Amendment Report

UNSW G25 Education Building

16 December 2025 | SSD-74670005

Figure 3 Part 5 Approved Works Plan (key areas of work outlined in red)

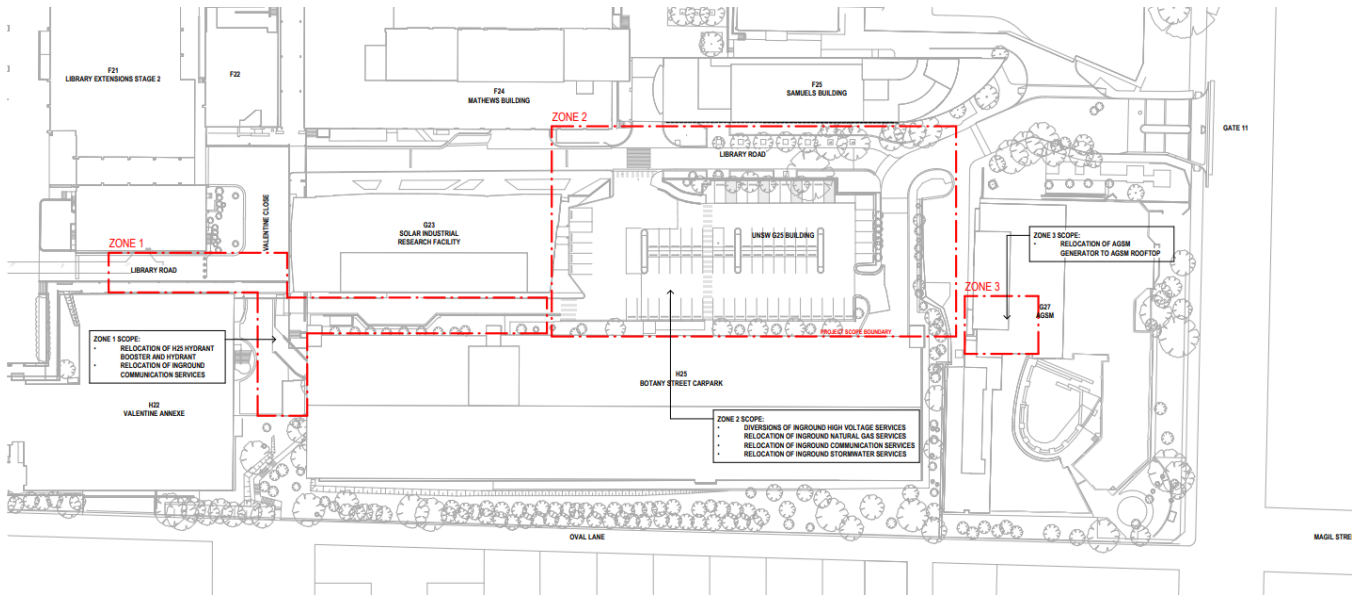
- Relocation of a generator;
- Relocation of hydrant and booster infrastructure;
- Inground service diversions including the electrical infrastructure, main gas pipeline, telecommunications cabling, and stormwater infrastructure; and
- Associated demolition works and capping of infrastructure services.

Refer to **Figure 3** below for the area of these Part 5 approved works.

Figure 4 Approved Part 5 demolition works (in blue) and SSD demolition works (in red)

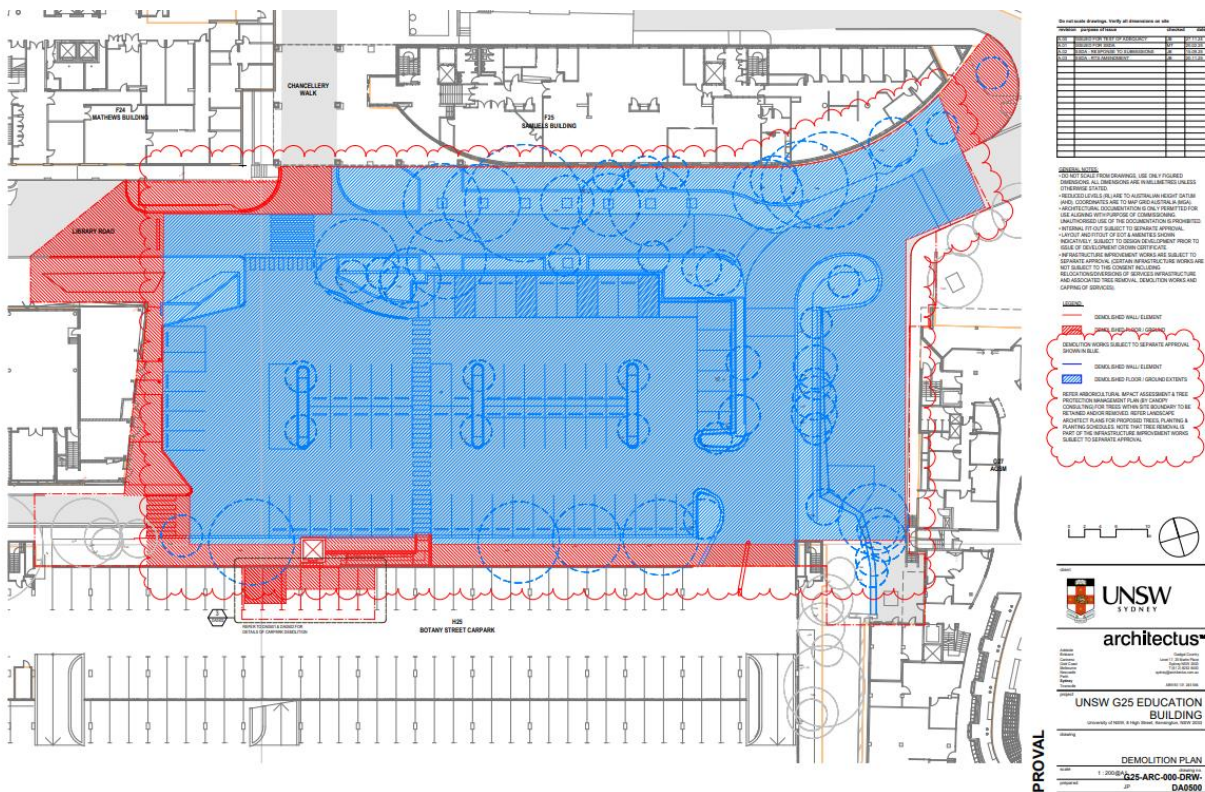
The following Figures 4-6 refer to the SSD plans and reports which have required updating in this Amendment Report to remove these Part 5 approved works. Refer to **Figure 4** below which shows the area of the Part 5 approved demolition works associated with the infrastructure improvement works and the area of the SSD demolition works (Refer to the amended demolition plan from the Architectural plans, at **Appendix A1**).

The SSD demolition works are amended to delete the at-grade car parking demolition works, while some demolition works remain required, where located outside the infrastructure works area (see **Figure 4** above), and also for the minor demolition works within the multi-storey car park for lift relocation. (Refer to Amended Architectural demolition plan at **Appendix A1**).

Figure 6 Proposed stormwater plan excerpt

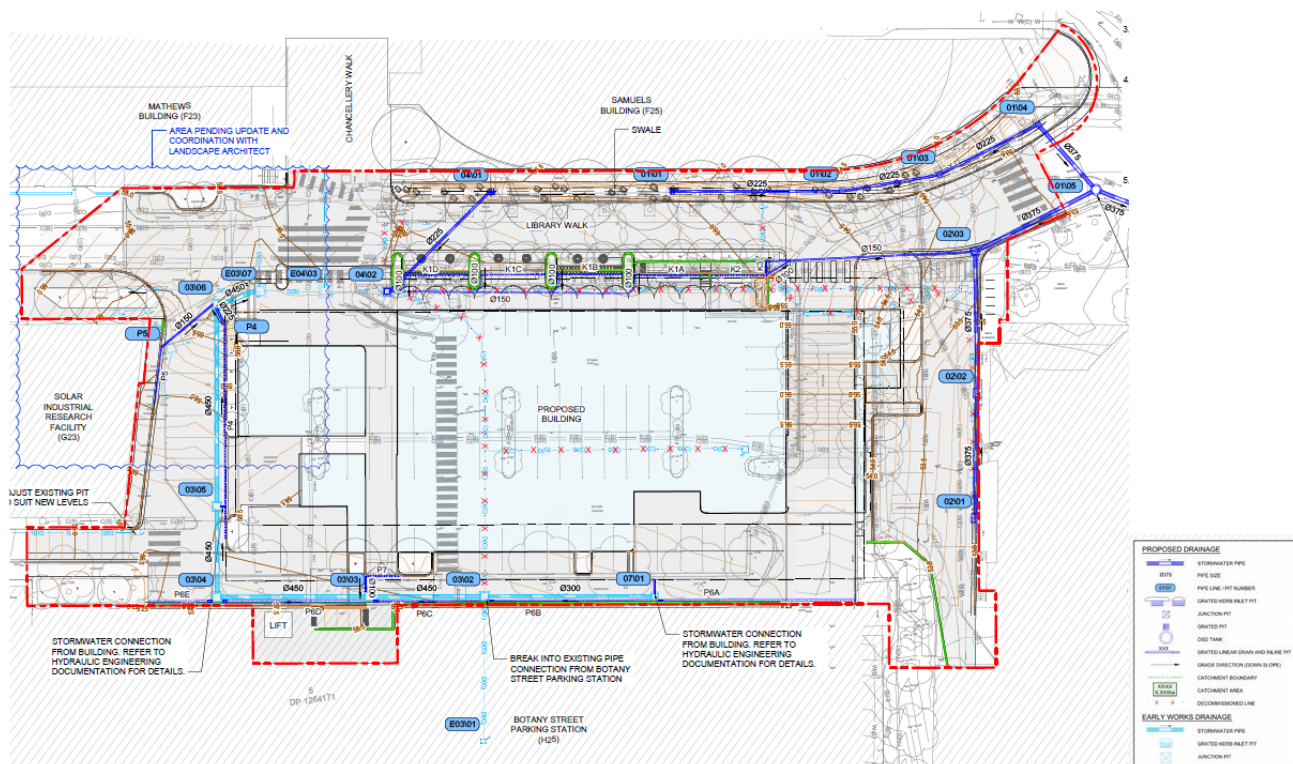
See also **Figure 6** below showing the Part 5 approved stormwater diversion works (removed from SSD via updated Civil Design letter at **Appendix A4**).

- o *Stormwater infrastructure* – to maintain the existing stormwater system across the upper campus, a stormwater pipe will be diverted and rerouted with no changes to catchment delineation and aligning with the university's 2025 Stormwater Strategy Masterplan, while traversing the G25 car park area. This diversion is proposed to be excluded from the SSD documentation with an amendment required to the original Civil Design Report and Addendum Letter (refer Amended Civil Design Letter at **Appendix A4**) and demolition area is now to be excluded from the SSD demolition plan.
